Submission to The Proposed Amendment (2012) To The Algonquin Provincial Park Management Plan

Submitted by the Algonquin Backcountry Recreationalists

September 11th, 2012

A1 - 2012

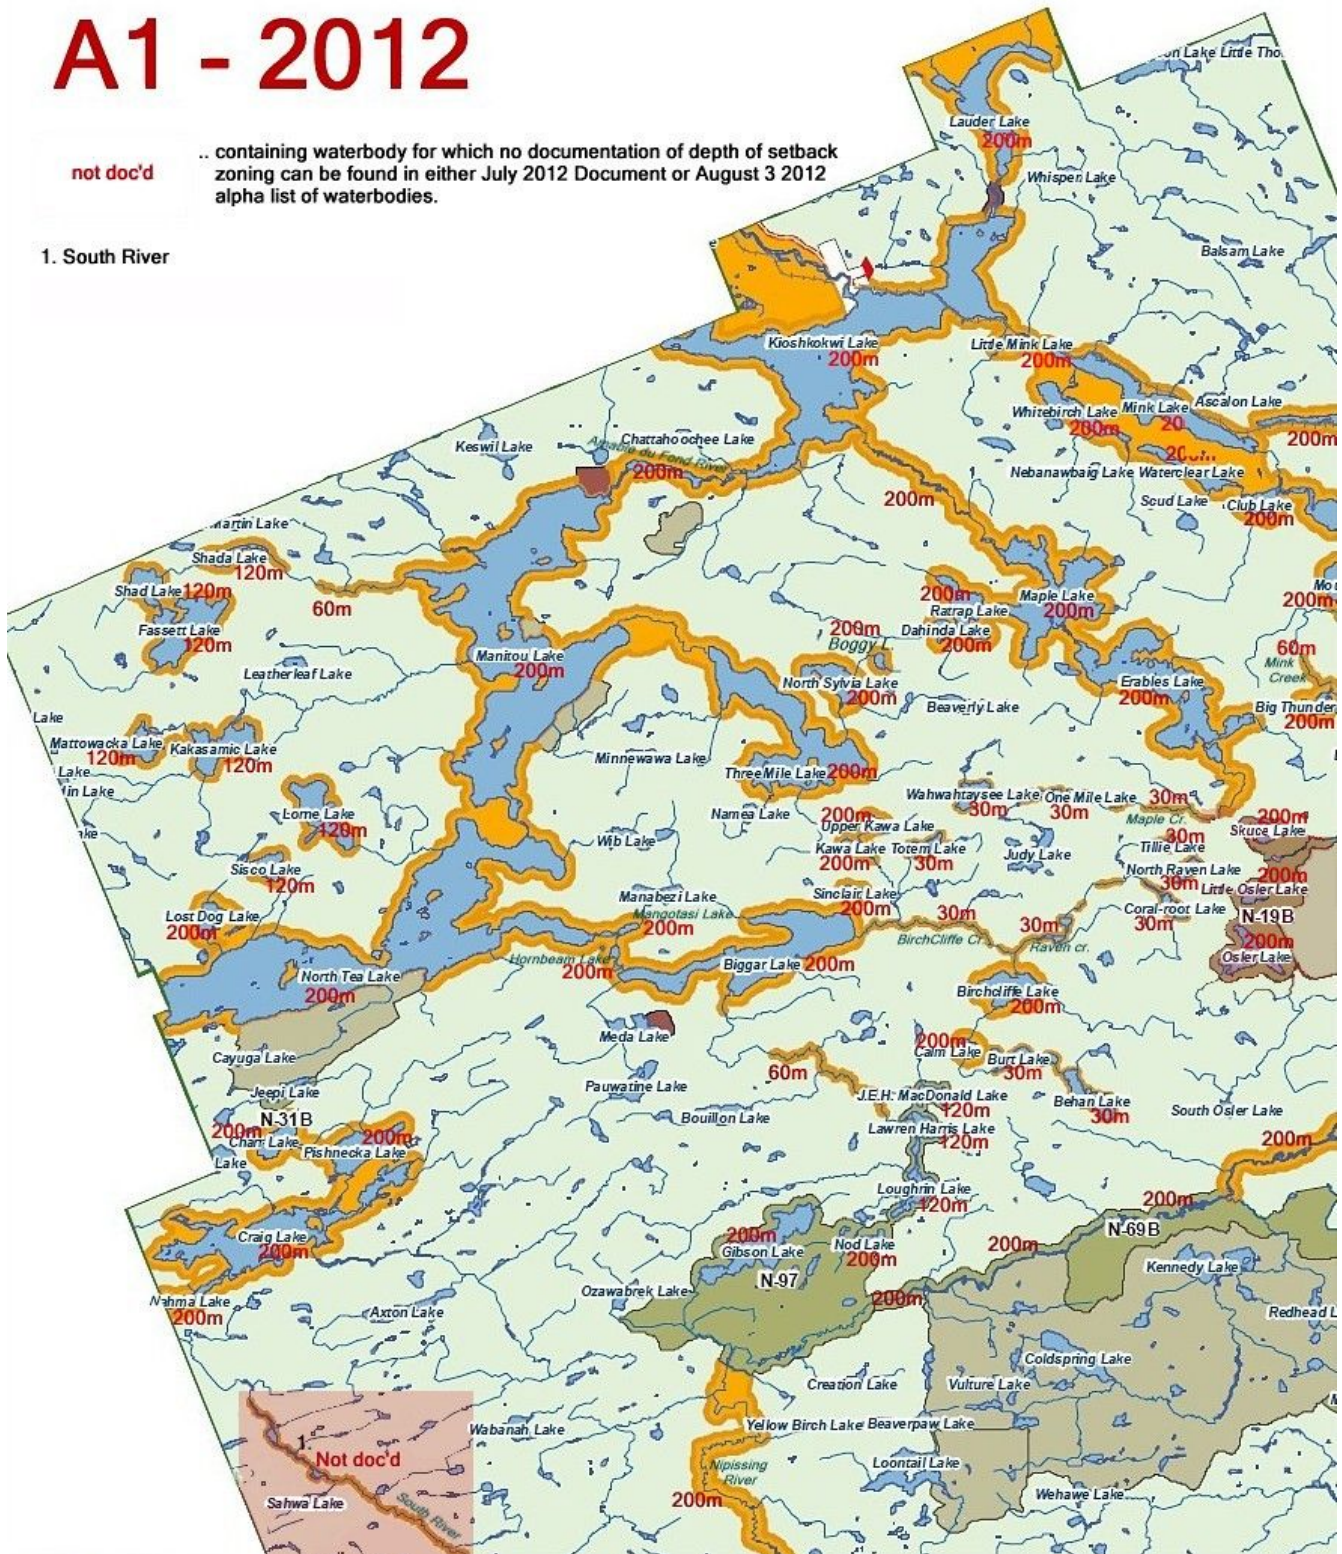
.. containing waterbody for which no documentation of depth of setback zoning can be found in either July 2012 Document or August 3 2012 alpha list of waterbodies.

Map A1 – 1. South River .. while it is illustrated on the Figure 3b Map as having a “shallow setback zoning”, it is not described in either of the other two documents. (also on Map B1)

A2 - 2012

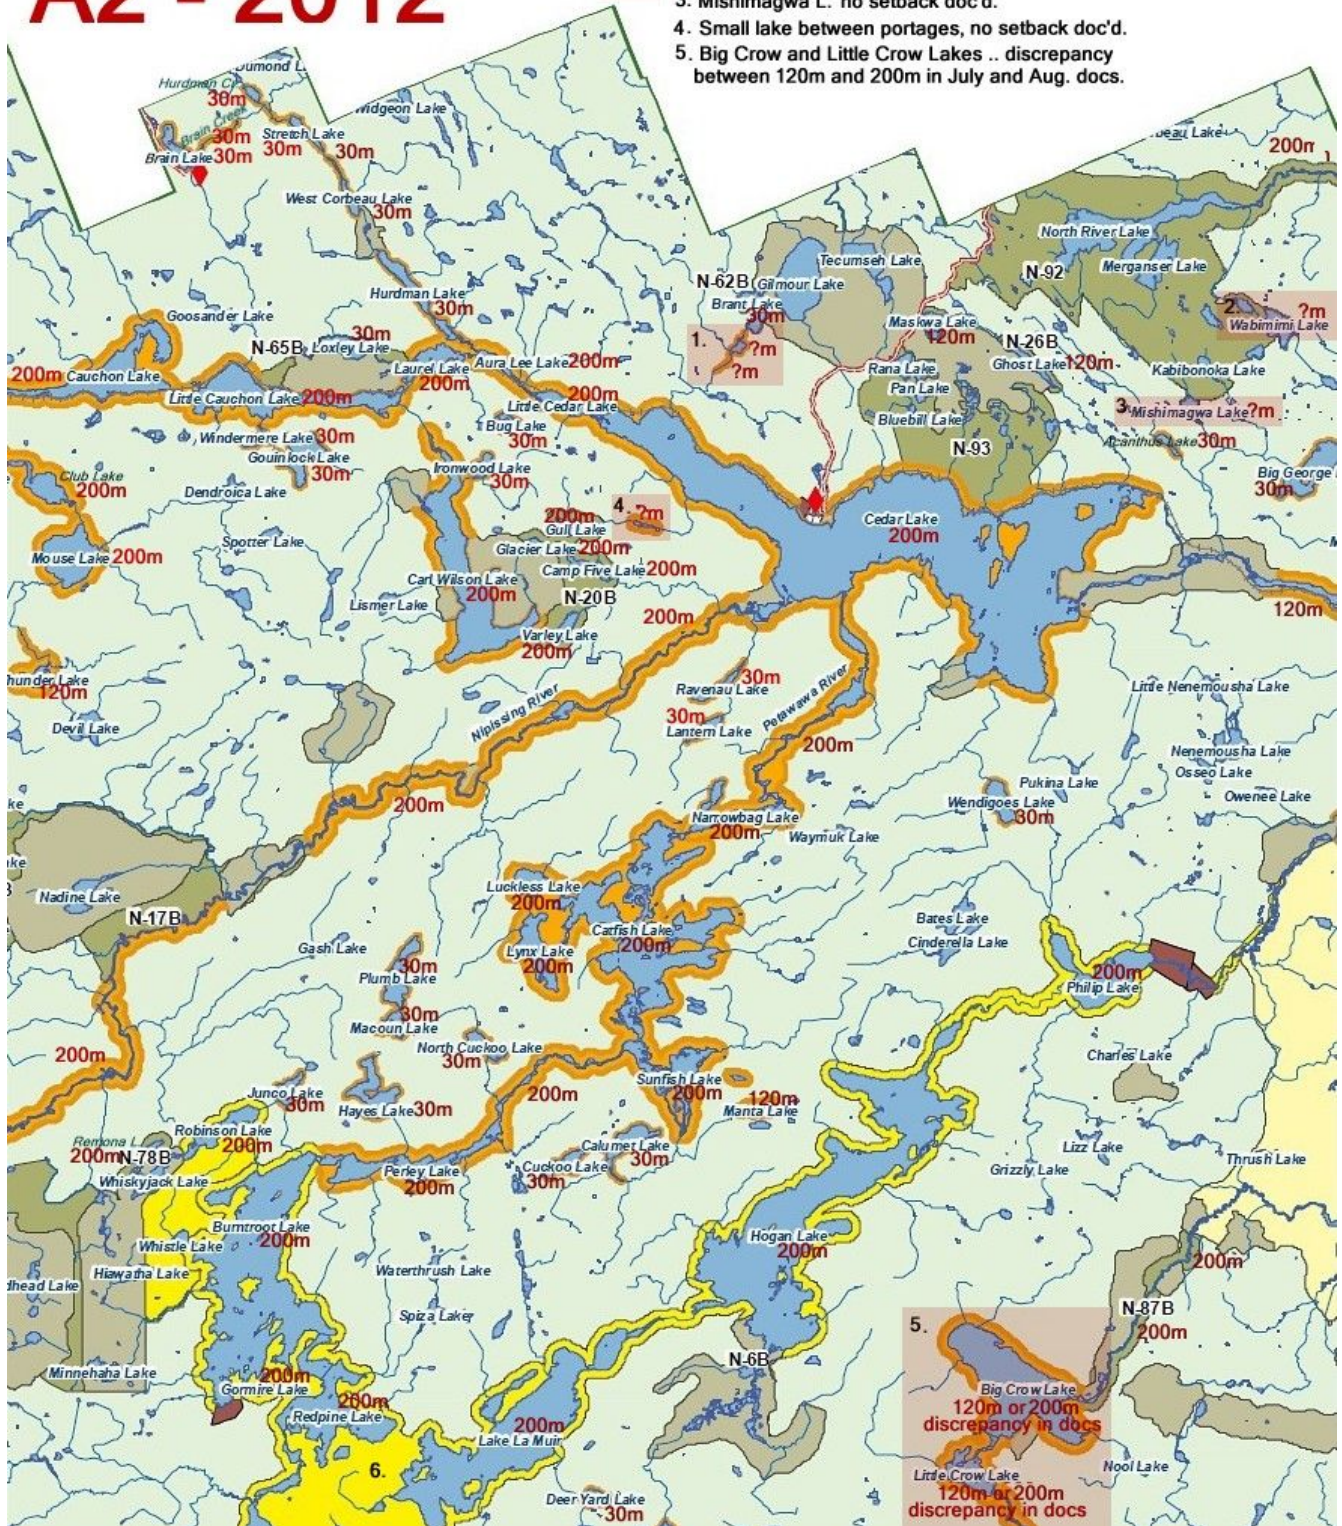
1. Un-named lake and creek section SW of Brant Lake, no setback doc'd.
2. North side of Wabimimi L., no setback doc'd.
3. Mishimagwa L. no setback doc'd.
4. Small lake between portages, no setback doc'd.
5. Big Crow and Little Crow Lakes .. discrepancy between 120m and 200m in July and Aug. docs.

Map A2 – 1. Un-named lake and creek section SW of Brant Lake .. while they are illustrated on the Figure 3b Map as having a “shallow setback zoning”, they are not described in either of the other two documents.

Map A2 – 2. North side of Wabimimi Lake .. despite being within N-92, the lake's north side has no setback zoning described in either of the other two documents..

Map A2 – 3. Mishimagwa Lake .. despite being within N-92, the lake's “outer” sides have no setback zoning described in either of the other two documents.

Map A2 – 4. Un-named Lake.. a small lake between portages, it has no setback zoning described in either of the other two documents.

Map A2 – 5. Big Crow and Little Crow Lake.. there's a discrepancy in documented setback zoning. Page 11 of July 2012 document reads 120 meters, while the Table 1 listing reads 200 meters.

Concern 5: The ABR believes that since setback zonings on the Crow River are 200 meters, that both lakes should have the 200 meter setback zoning, as documented in the later Table 1.

A3 - 2012

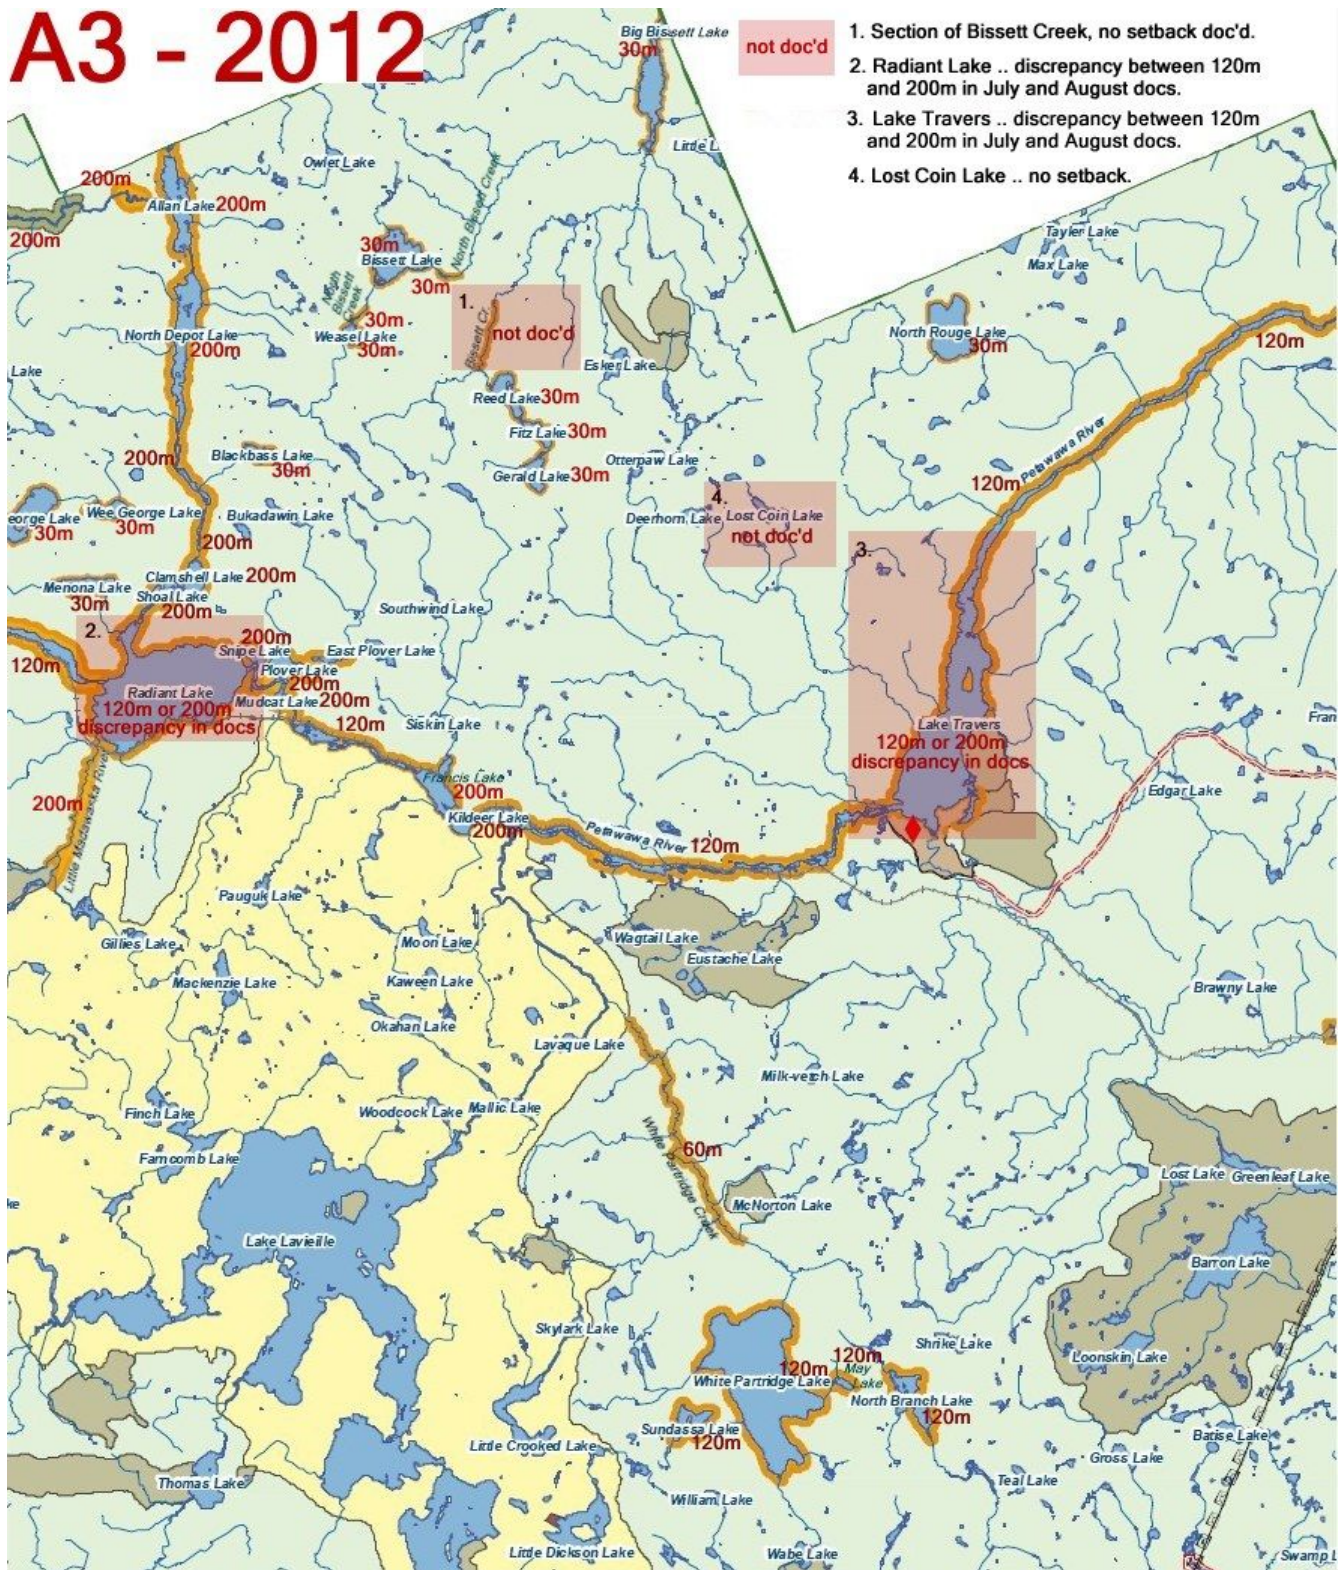
Map A3 – 1. Section of Bissett Creek .. while it is illustrated on the Figure 3b Map as having a “shallow setback zoning”, the zoning's depth is not described in either of the other two documents.

Map A3 – 2. Radiant Lake .. there's a discrepancy in documented setback zoning. Page 11 of July 2012 document reads 120 meters, while the Table 1 listing reads 200 meters.

Map A3 – 3. Lake Travers .. there's a discrepancy in documented setback zoning. Page 11 of July 2012 document reads 120 meters, while the Table 1 listing reads 200 meters.

Map A3 – 4. Lost Coin Lake .. it has no setback zoning described in any of the documents.

- 1. Section of Bissett Creek, no setback doc'd.
- 2. Radiant Lake .. discrepancy between 120m and 200m in July and August docs.
- 3. Lake Travers .. discrepancy between 120m and 200m in July and August docs.
- 4. Lost Coin Lake .. no setback.

Concern 6: Given that setback zonings for many lakes along the Petawawa River are documented on the latest listing as 200 meters, the ABR maintains that both Radiant Lake and Lake Travers should also have setback zonings of 200 meters.

Concern 7: In addition, the ABR maintains that the entire Petawawa River itself should have a setback zoning of 200 meters along its entire length.

Concern 8: The ABR maintains that Lost Cabin Lake deserves a 120 meter setback zoning, given the brook trout fishing and the rented cabin. (described in more detail on page 1 as Concern 1 of this submission)

A4 - 2012

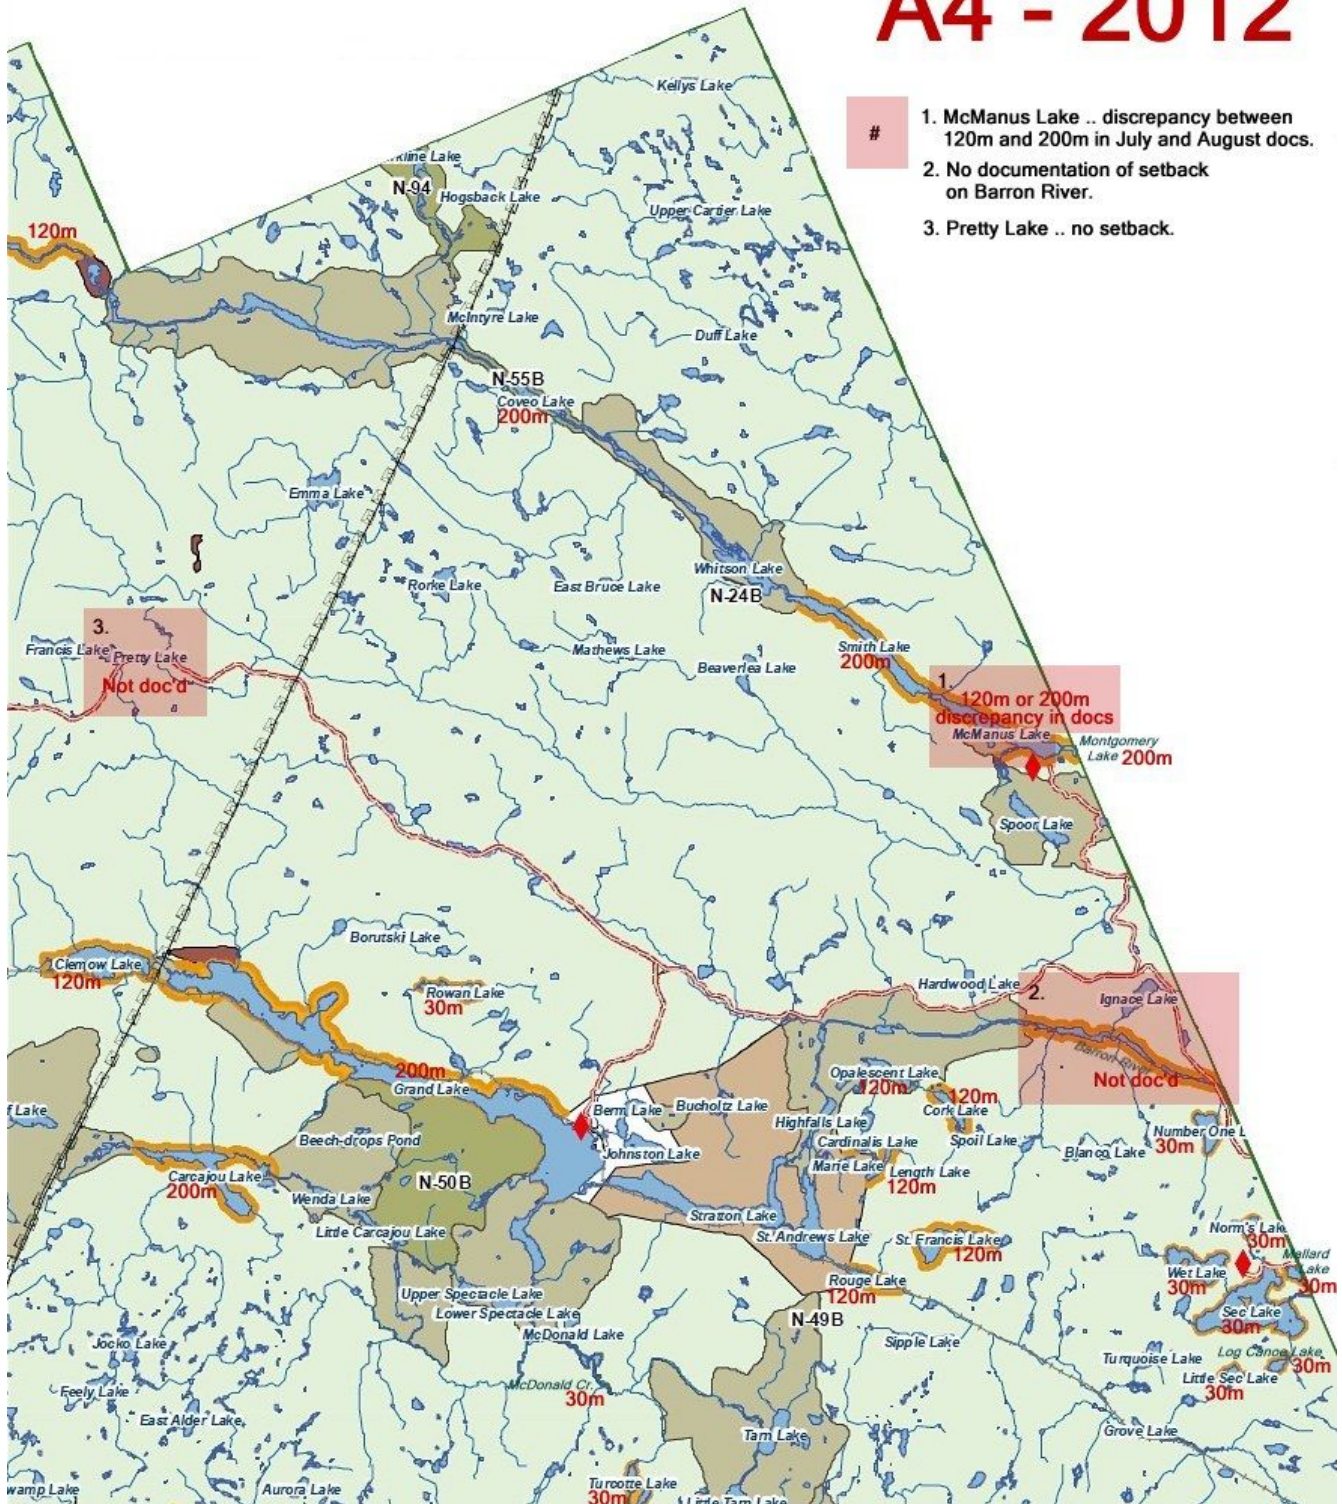
Map A4 – 1. McManus Lake.. there's a discrepancy in documented setback zoning. Page 11 of July 2012 document reads 120 meters, while the Table 1 listing reads 200 meters.

Map A4 – 2. Barron River .. while it is illustrated on the Figure 3b Map as having a setback zoning, the zoning's depth is not described in any of the documents.

Map A4 – 3. Pretty Lake .. it has no setback zoning described in any of the documents.

Concern 9: Setback zonings for many lakes along the Petawawa River are on the latest listing as 200 meters, The ABR maintains McManus Lake should also be 200 meters.

Concern 10: The ABR maintains that the Barron River's setback zoning should be documented as 200 meters.

Concern 11: The ABR maintains that Pretty Lake deserves a 120 meter setback zoning. (described in more detail on page 2 as Concern 2 of this submission)
